Response to Comments on the Specification Discussion Guide

Part 2 Version 7 ENERGY STAR® for Windows, Doors, and Skylights

Figure 1. Distribution of Door Performance by Glazing (Lite) Level

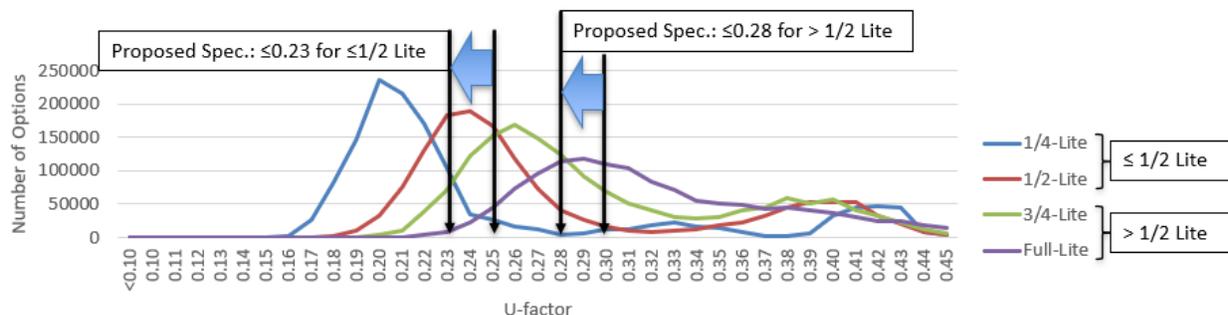
One commenter explains that door glass assembly components constructed with the same materials perform differently depending on the number of square inches of glazing area in relation to the door slab. It is easier for 1/4-lites to qualify for ENERGY STAR than 1/2-lites, and it is easier for 3/4-lites to qualify than it is for full-lites for many glazing packages. The commenter recommends comparing the total cost of an insulating glass unit (IGU) used in an ENERGY STAR qualified door at the various glazing sizes defined by NFRC.

EPA appreciates the suggestions for door cost analysis. However, EPA was only able to gather insulating glass components and completed product cost information. The wide variety and types of doors slabs, glass inserts, and frames made it difficult to gather door data. Instead, EPA evaluated door performance and technical feasibility by looking at the U-factor distribution of doors by the amount of glass. This analysis confirmed the commenter's point that it is easier for door configurations with less glass to meet their respective criteria levels. EPA believes that the proposed criteria provide consumers with more energy savings while still providing an opportunity for doors with more glazing to meet the criteria.
